HISTORIC AND DESIGN REVIEW COMMISSION

Agenda Item No: 20

HDRC CASE NO: 2016-020
ADDRESS: 139 E COMMERCE ST
141 E COMMERCE ST
143 E COMMERCE ST
106 RIVERWALK
145 E COMMERCE ST
147 E COMMERCE ST
149 E COMMERCE ST
151 E COMMERCE ST
LEGAL DESCRIPTION: NCB 106 BLK LOT 27
NCB 106 BLK LOT 28
NCB 106 BLK LOT 29 & 30
NCB 106 BLK LOT 31
ZONING: D HS RIO-3, D RIO-3
CITY COUNCIL DIST.: 1
LANDMARK: Commercial Building
APPLICANT: KHI, Inc
OWNER: Burgos LP / Uriarte LP
TYPE OF WORK: Demolition with new construction of a mixed use, mid-rise tower
REQUEST:

The applicant is requesting conceptual approval to:

1. ILLUSTRATE THE MASSING AND SETBACKS

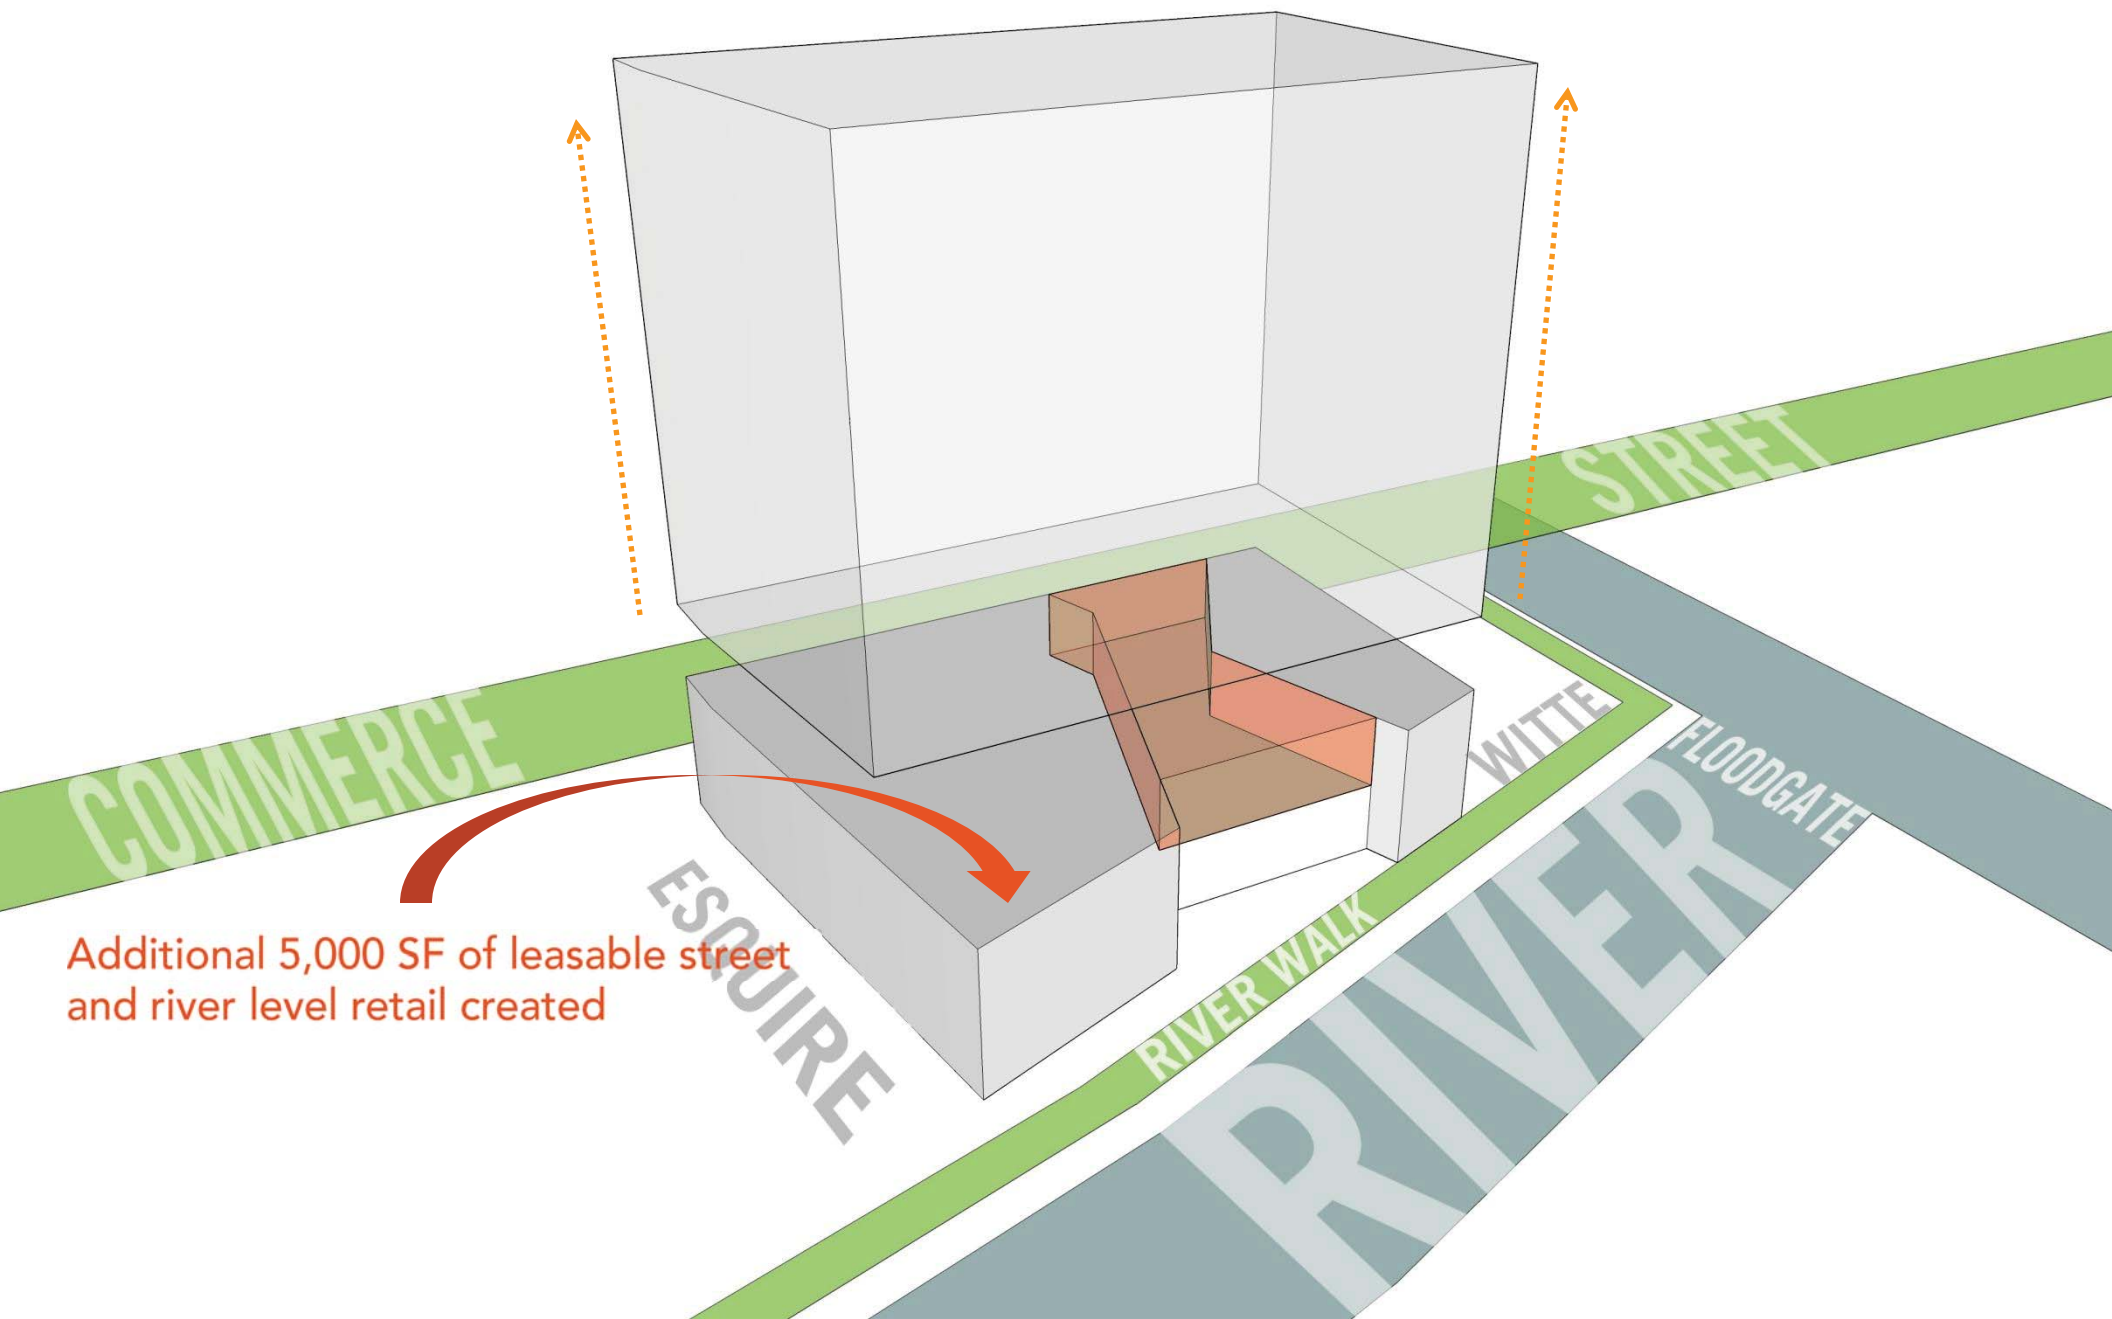
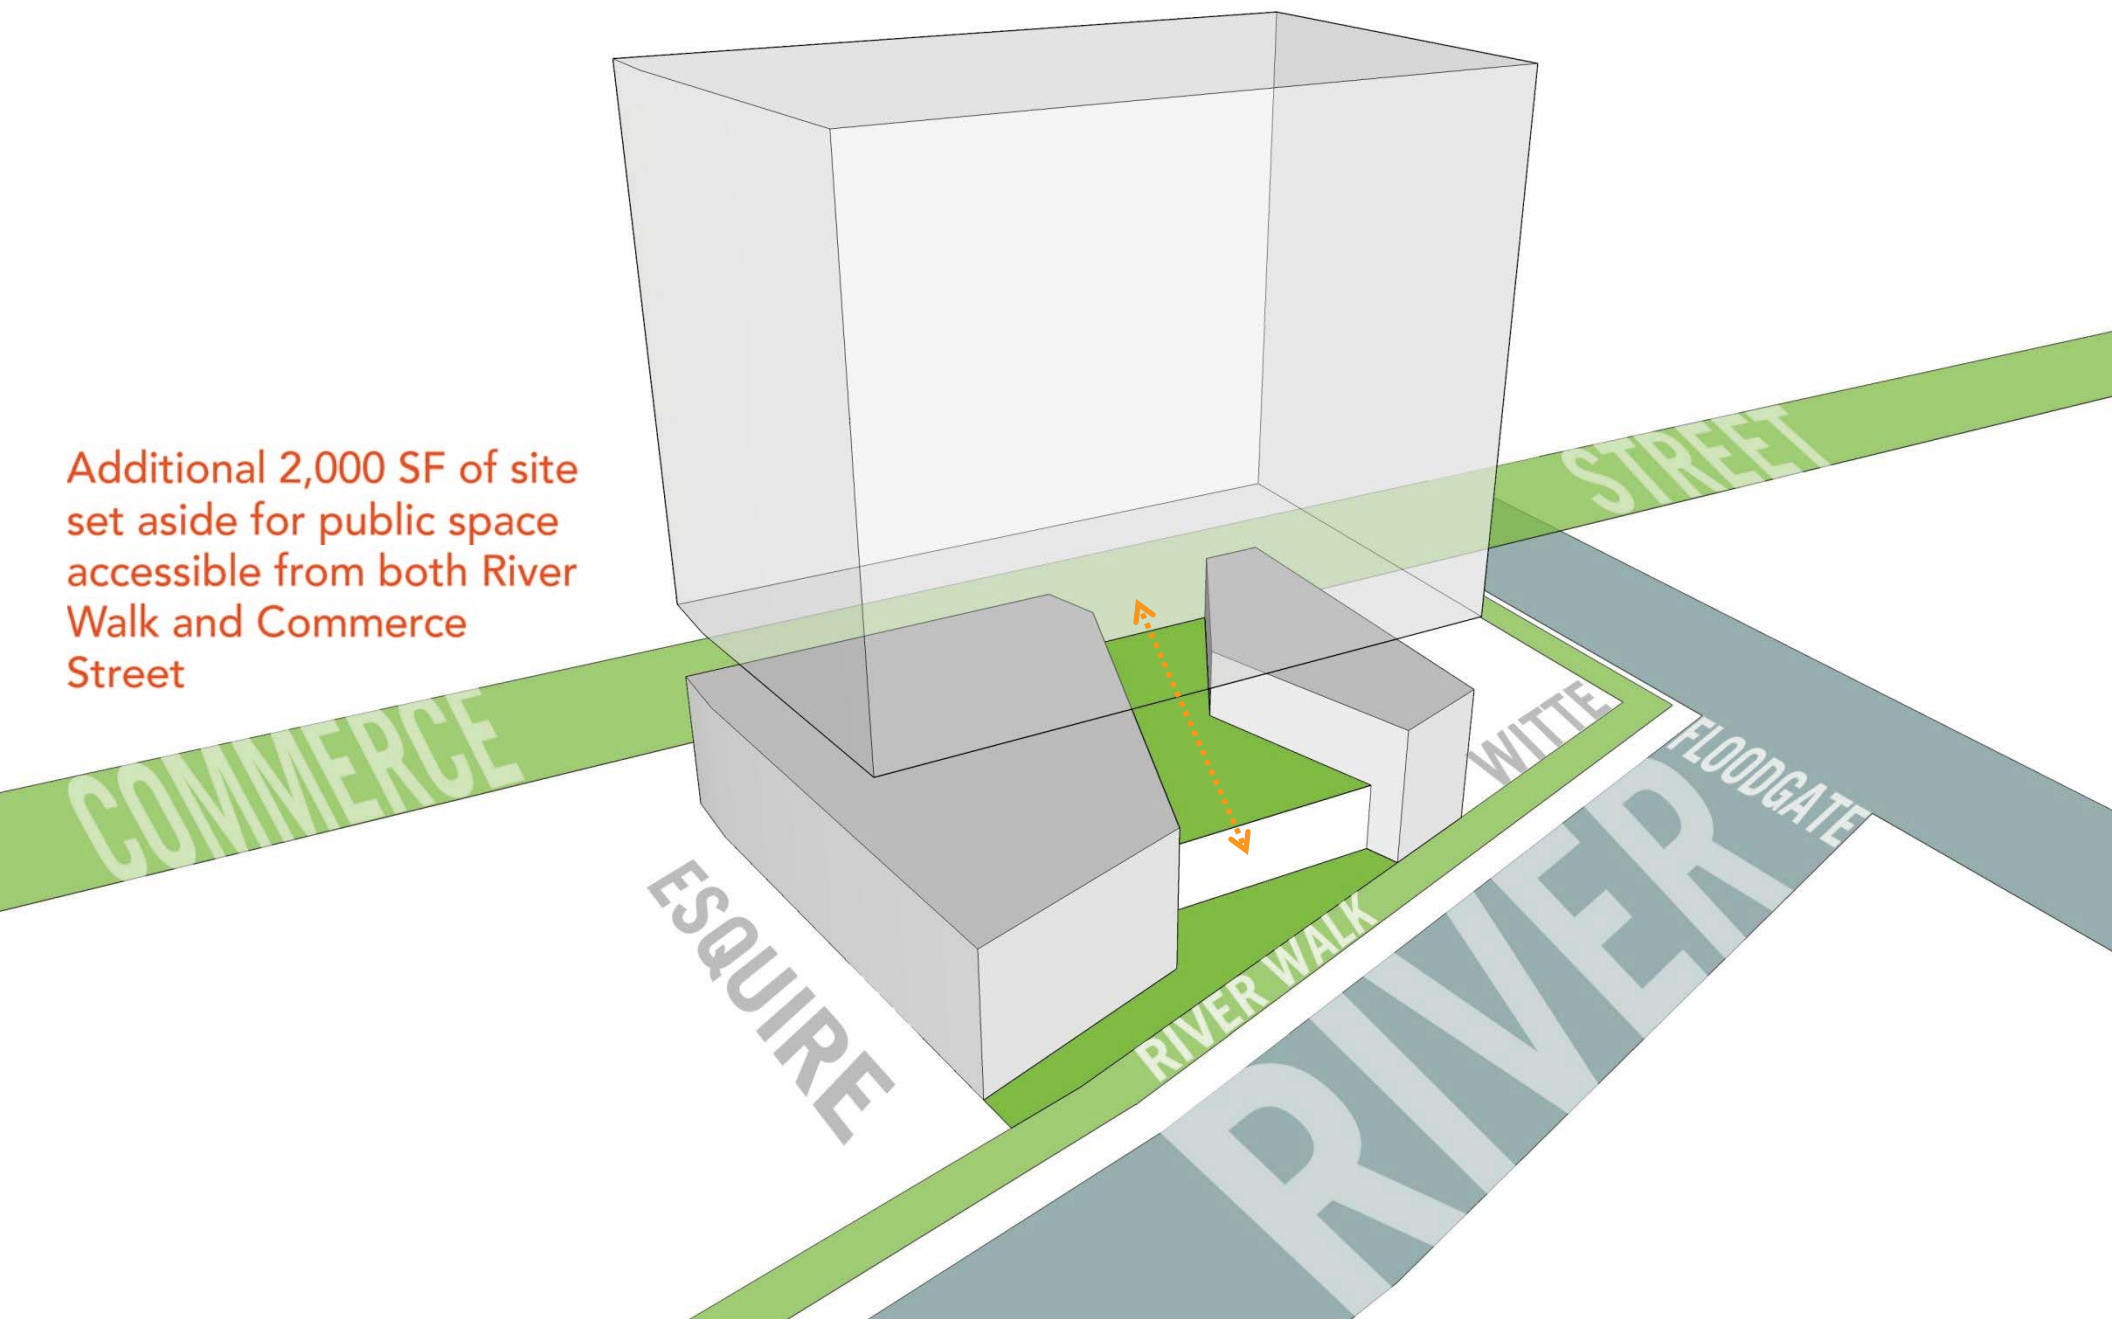
- a. This request was reviewed by the Design Review Committee on January 5, 2016, where committee members expressed concern over the existing stone walls that hold historic characteristics, asked questions regarding parking, the introduction of pedestrian traffic from E Commerce to the Riverwalk through the site, the connection of new paving materials to existing Hugman materials, how the existing Witte Building's façade might be translated into that of the new construction and noted that overall the proposal was attractive. At an HDRC hearing on March 16, 2016, concern as expressed regarding the treatment of the river level and the extent of the proposed removal of historic stone walls. The item was referred back to the Design Review Committee which met and reviewed this request a second time on March 22, 2016. The applicant provided updated drawings which address the stated concerns included the re-use of additional stone elements at the river level, creating additional articulation at the east and west facades, clarification on the parking garage driveway design, and an illustration that shows the alignment of canopies along Commerce Street.

Approx. 10,000 SF site

Approx. 2,000 SF reduction
for setback or 20% of site

- Additional 1,000 SF reduction of mass along River Walk

- total of 30% of site dedicated to setbacks

Additional 5,000 SF of leasable street
and river level retail created

Additional 2,000 SF of site
set aside for public space
accessible from both River
Walk and Commerce
Street

REVISED EAST ELEVATION

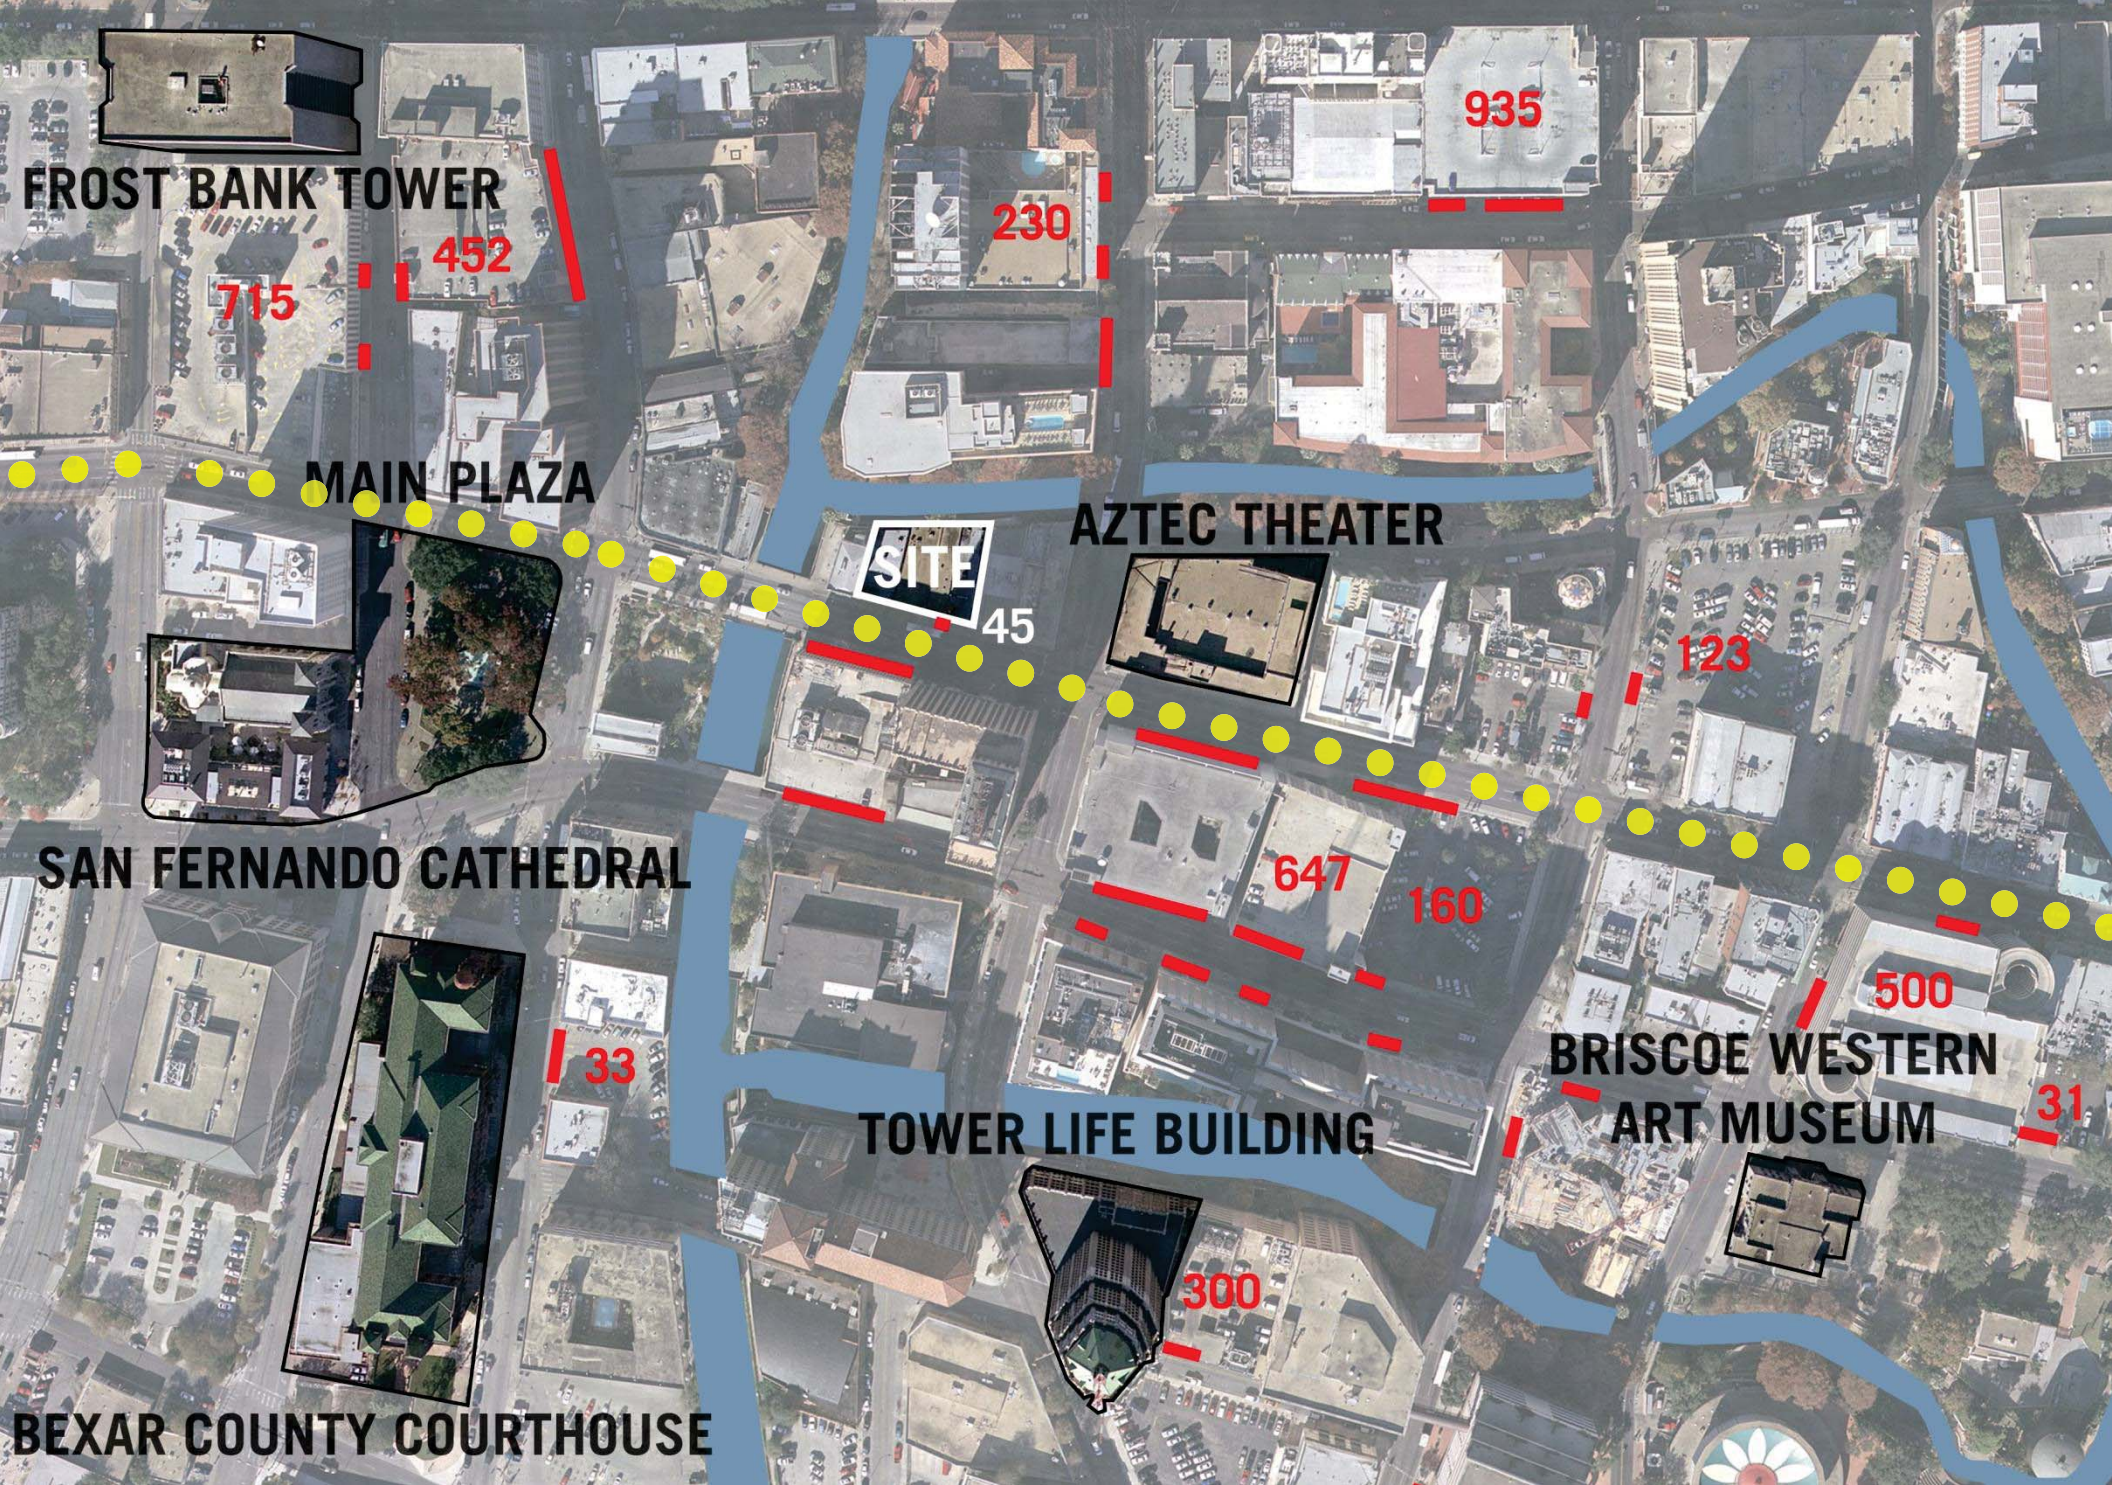
NG: can you make it read differently (river level elevation). TC: what is the pedestrian experience? MG DS: soften it w/ plant materials, planters
